Service Bulletin

Model : GP605

No.: GP605-001
(FF-T01-K1-000003-01)

Subject : DAMAGE TO MICROSWITCH INSIDE REGISTRATION / TRANSFER ASSEMBLY

Fig. 1 Transfer / Separation charging assembly

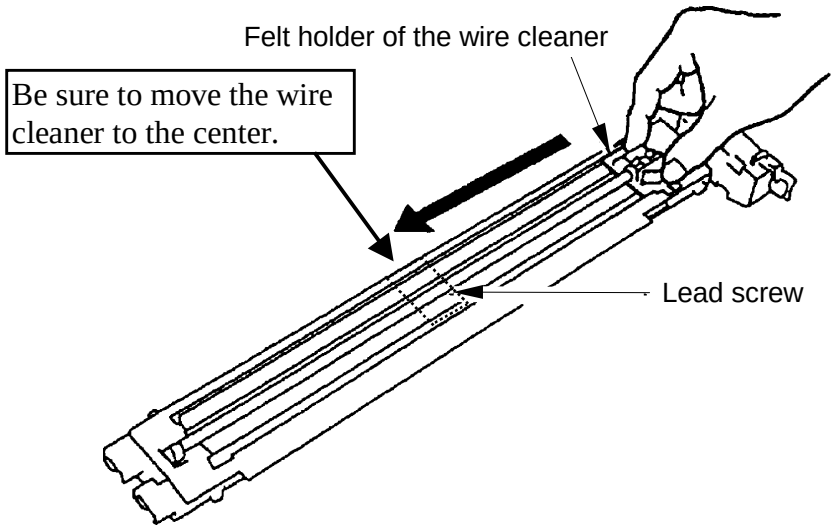
Reason : When installing a transfer / separation charging assembly, there is the possibility of causing damage to the microswitch in the registration / transfer assembly. Due to this concern, instructions to follow during servicing are given.

Details : <Symptom>
The presence the felt holder at the home position or away from it cannot be detected, and error code E063 is displayed.

<Cause>
When installation of the transfer / separation charging assembly is performed with the felt holder of the wire cleaner of this assembly at the home position, the protruding part of the felt holder comes into contact with the microswitch actuator in the registration / transfer assembly. And depending on how this contact is made, the actuator may deform or detach to result in the quality problem (error code E063).

Servicing **:** When installing the transfer / separation charging assembly, proceed with the installation work after moving the wire cleaner with its felt holder to the center. (See P6-59 of Service Manual for details.)

Fig. 2

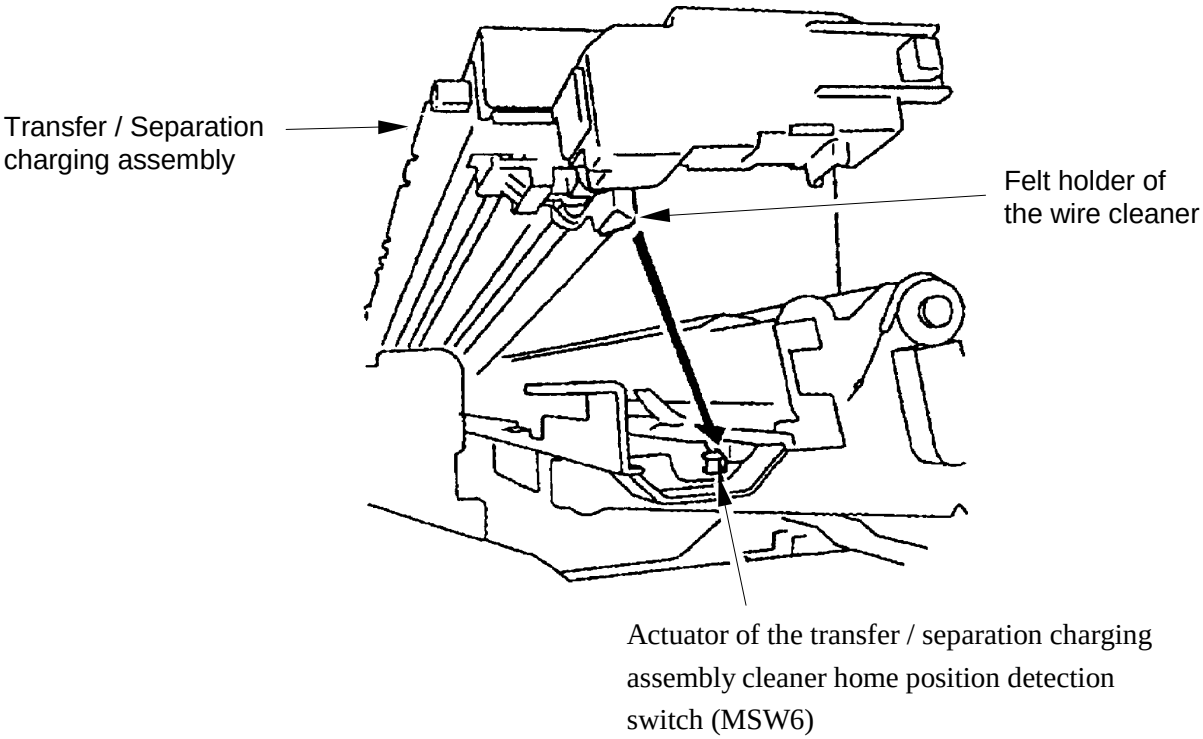
* If the wire cleaner is not moved to the center, it may come into contact with the microswitch actuator at the home position as shown in the figure below, causing deformation or detachment.
